Mercedes-Benz

Campaign No. 2014040002, April 2014

SUBJECT: **Models X166 (GL), Model Year 2014**
Replace Second Row 60% Seat Pan

Figure 1

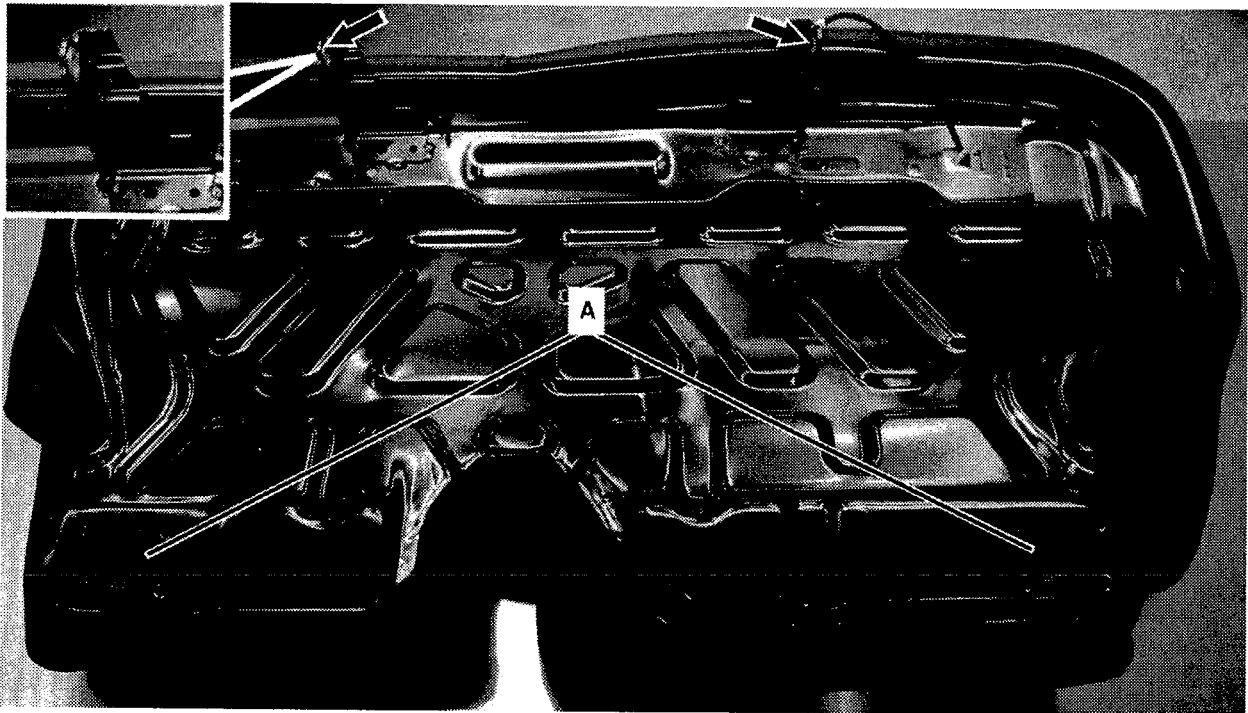
- Be sure to transfer grommets (A, Figure 1) and plastic sleeves with washers (arrows) from "old" seat cushion frame (pan) to "new" seat cushion frame (pan).
- Reinstall cable tie mounting clip (attached to seat wiring harness) to new seat cushion frame (pan).
- Secure seat wiring harness to new seat cushion frame (pan) with cable tie.
